1 Q. Reference: RRAS, 2022 Update, Vol. I, page 13 (37 pdf)

Figure 1: Newfoundland and Labrador Model Topography prior to the Decommissioning of L1301

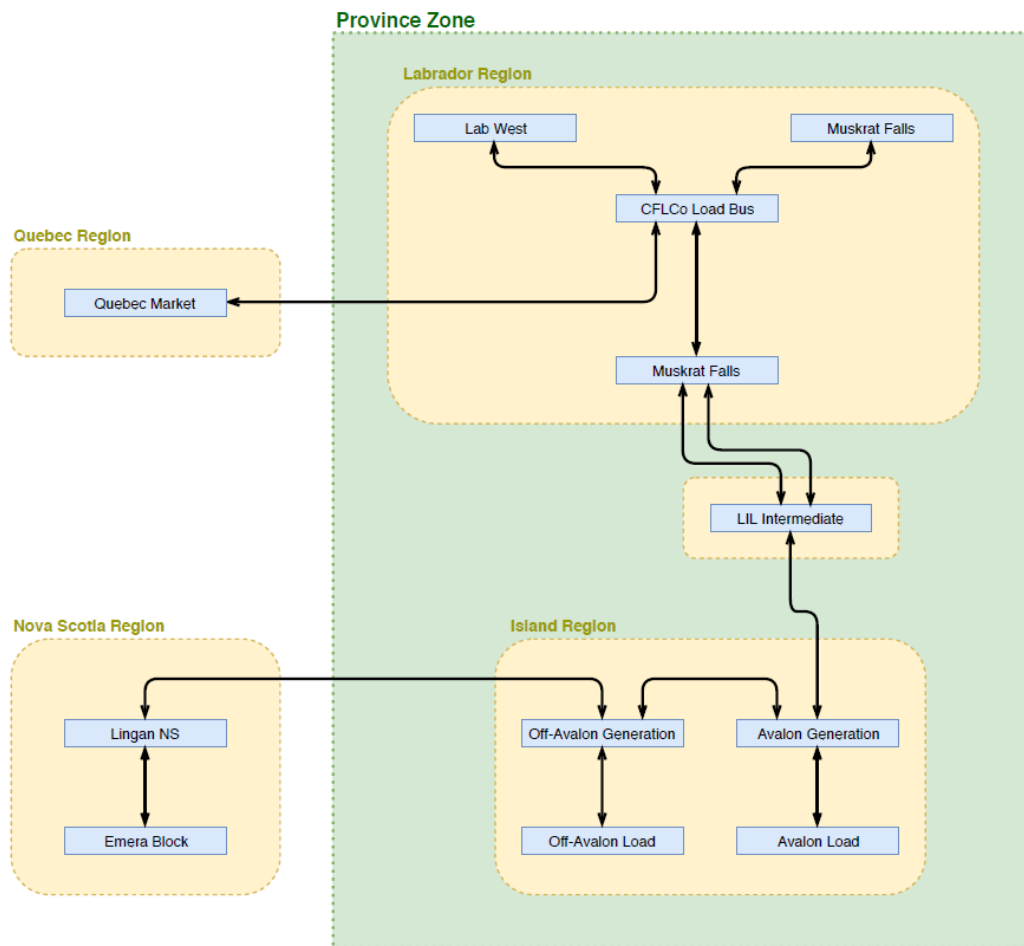
2 Please confirm that the Model Topography shown in Figure 3 represents the situation after the
3 decommissioning of Line L1301, and that, prior to that decommissioning, there was also an
4 arrow connecting CFLCo Load Bus to Lab East.

7 A. Yes, this is correct. For comparison, the equivalent figure from the “Reliability and Resource
8 Adequacy Study,”¹ prior to the decommissioning of L1301, is provided as Figure 1
